REPORT AMENDED BY STAFF 2-26-87
CITY PLANNING COMMISSION

- APPLICATION:**
- A. Negative Declaration
 - B. Special Permit to establish a restaurant in the EA-2 zone
 - C. Special Permit for a drive-up window

LOCATION: 2426 Fruitridge Road

P87-069

SITE PLAN

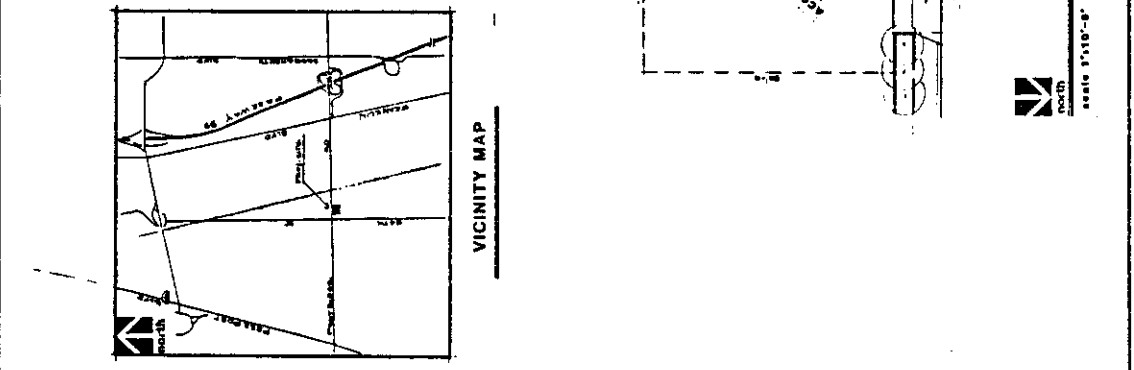
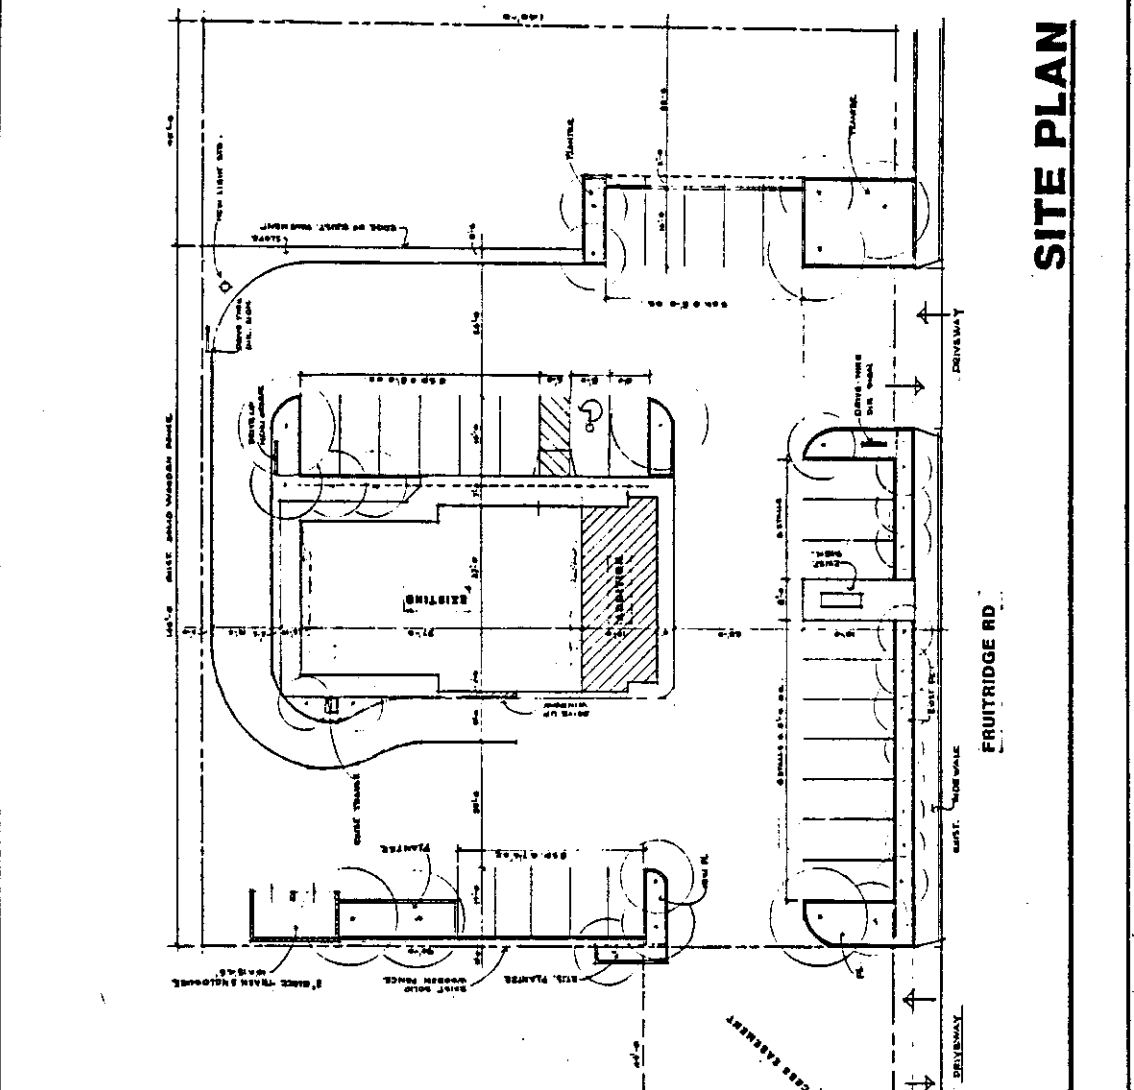
1. Drive-up window lanes will block departing vehicles from the six side stalls when storage lane is full.
2. Full size stalls to be a minimum of 18 feet in depth. Compact stalls to be a minimum of 16 feet in depth.

There is a 50-foot setback required on Fruitridge Road. Plans shall be redesigned to increase the front setback from 48 feet to 50 feet.

There is a 50-foot setback required on Fruitridge Road. Plans shall be redesigned to increase the front setback from 48 feet to 50 feet.

1. Seating shall be limited to 58.
2. The applicant shall submit detailed landscaping and irrigation plans for staff review and approval prior to issuance of building permits.
3. The applicant shall redesign the parking lot striping to comply with the Zoning Ordinance dimension requirements and eliminate conflict with the drive-up window stacking space.
4. The site plan shall be redesigned to reflect a 50-foot setback on Fruitridge Road.
5. ~~No/pole sign/shall/be allowed./~~ A monument sign with a maximum height of 12 feet shall be allowed/
5. The applicant shall remove the top illuminated portion of the existing pole sign and repair the remaining portion for use with the current project (staff added)
